#### **Addendum 128– UN Regulation No. 129**

#### **Revision 1 – Amendment 3**

Supplement 2 to the 01 series of amendments – Date of entry into force: 10 February 2018

#### **Uniform provisions concerning the approval of Enhanced Child Restraint Systems used on board of motor vehicles (ECRS)**

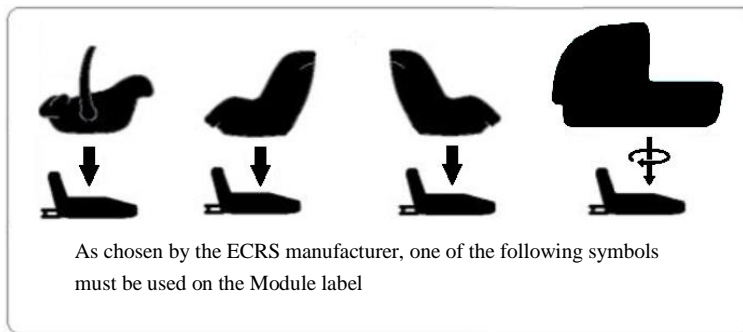
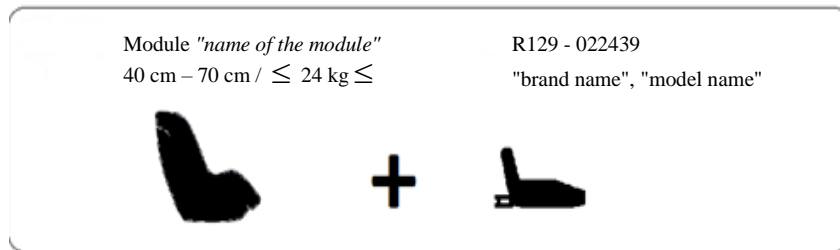
Annex 2, Arrangements of the module mark in combination with an approval mark, the figures, to be deleted and insert new figures, to read:
